APPLICATION NO.	FILING DATE	FIRST NAMED INVENTOR	ATTORNEY DOCKET NO.	CONFIRMATION NO.
10/517,742	07/20/2005	Hartmut Ressel	10191/3901	6162
26646	7590	07/05/2006	EXAMINER	
KENYON & KENYON LLP ONE BROADWAY NEW YORK, NY 10004			VU, BAO Q	
			ART UNIT	PAPER NUMBER
			2838

Office Action Summary

10/517,742

Fig. 5

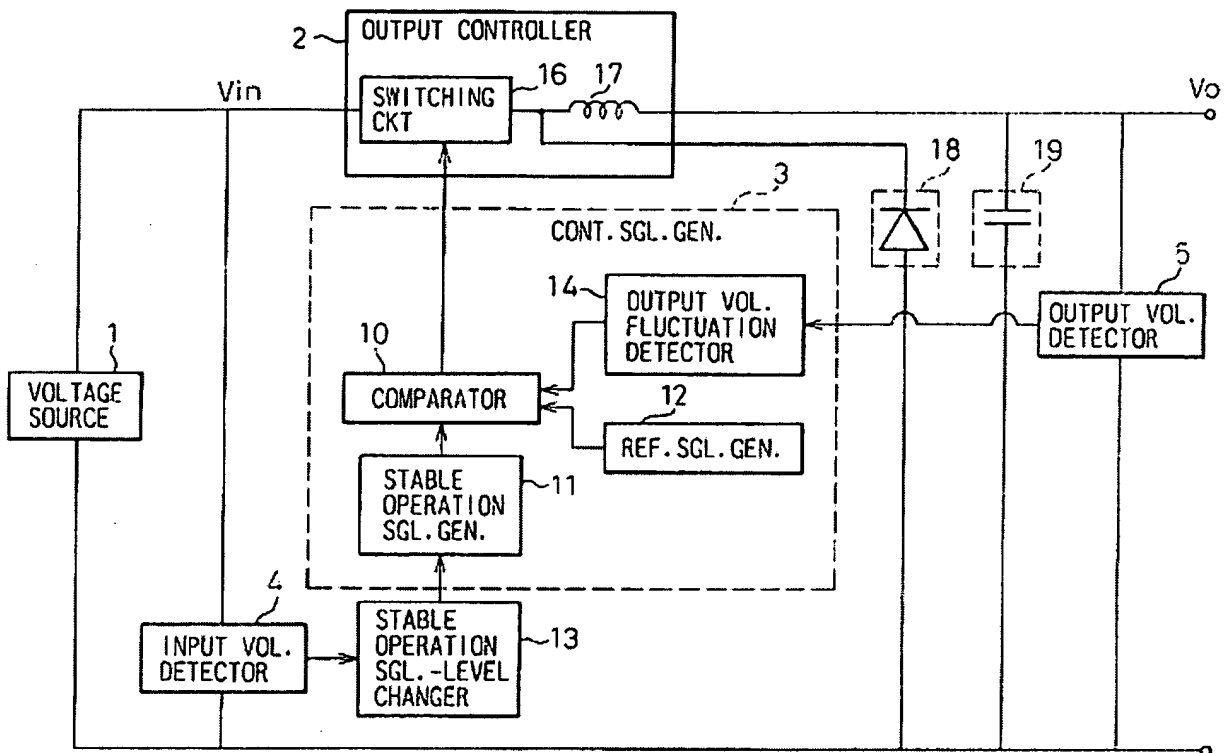
4. Claims 17, 18, 20-30, 32-34 are rejected under 35 U.S.C. 102(b) as being clearly anticipated by Saeki et al. (USP 5,572,112). Saeki discloses the claimed invention a switch device (16), a filtering circuit (19), a feedback device (5), a controllable amplifier (10), and a compensation signal-generating device (11). See figure below
